Rotor Panel Spare Part Number Changes

Issue	Date	Changes
1	07/07/2025	Technical parts bulletin created

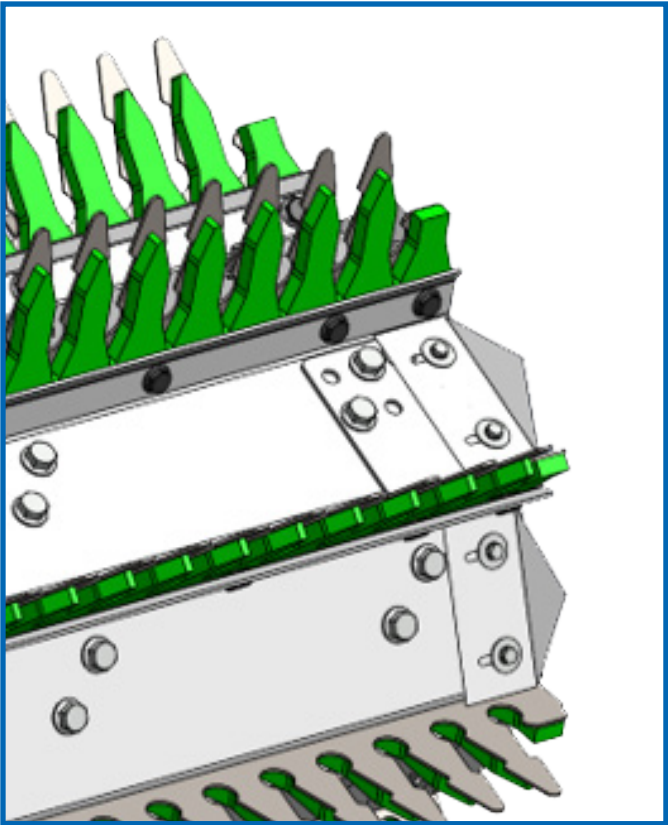
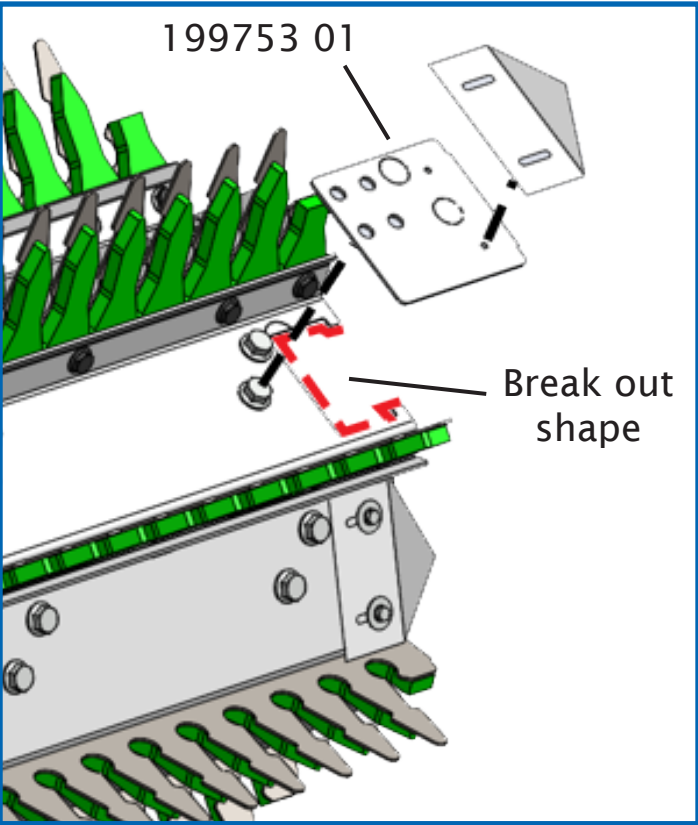
Stripping rotor panel spare part numbers have changed recently. See on page 2 a list of the original spare panel part numbers and the new.

New and old panels can be mixed on a rotor assembly.

The new spare parts have various knock out holes and sections so they can be broken out to produce the exact style of panel that is being replaced.

They also have an additional end knock out section that will assist with cleaning out debris that could get into the end of the rotor assembly.

If this facility is wanted on pre 2025 headers, then break out both ends on 2 panels and fit panels on directly opposite faces of the rotor assembly.

Additional cover plates (Part no. 199753 01 x 4 / rotor) will also be required to cover the clean out holes.
